Safety Evaluation Report

with Open Items Related to the License Renewal of
the Millstone Power Station, Units 2 and 3

Docket Nos. 50-336 and 50-423

U.S. Nuclear Regulatory Commission

Figure A: Trend Line Relationship with Horizontal Tendons

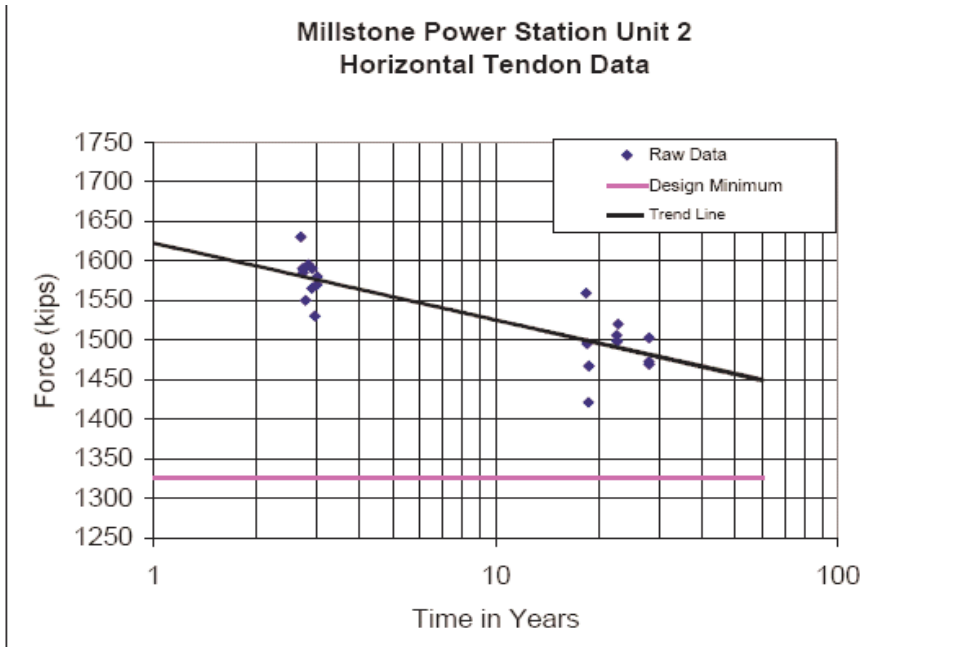
In RAI 4.5-4, the staff noted that the number of tendons sampled (i.e., 4 percent and 2 percent of the population of the group of tendons) during each tendon inspection is small, and that the sample size is not amenable to statistical analysis for establishing confidence levels (column 3 of Tables 4.5-1, 4.5-2, and 4.5-3) during each inspection based on the measured results. The staff also pointed out that, as the sample size of each tendon inspection is small, Attachment 3 of NRC Information Notice 99-10, Revision 1, recommended regression analysis of the measured tendon forces without averaging or any statistical calculation. The applicant was requested to provide more information about the values in column three of the identified tables and an explanation of measured tendon force values used in the regression analysis.

In its January 11, 2005 response, the applicant removed the tables provided in the LRA, and substituted new tables showing measured prestressing forces during tendon inspections for each group of tendons. In response to the staff's follow-up question as to why 3-, 5-, and 10-year data are missing from the tables, the applicant stated that as these tendons went through repeated tensioning and detensioning, the data were not reliable. The measurements taken during the 1-, 15-, 20-, and 25-year inspections were used for developing the trend lines. In Figures 1, 2, and 3 of the revised response (dated January, 11 2005), the applicant provided the trend lines and the measured tendon force data. Figure A, showing the trend line related to horizontal tendons, is reproduced below:
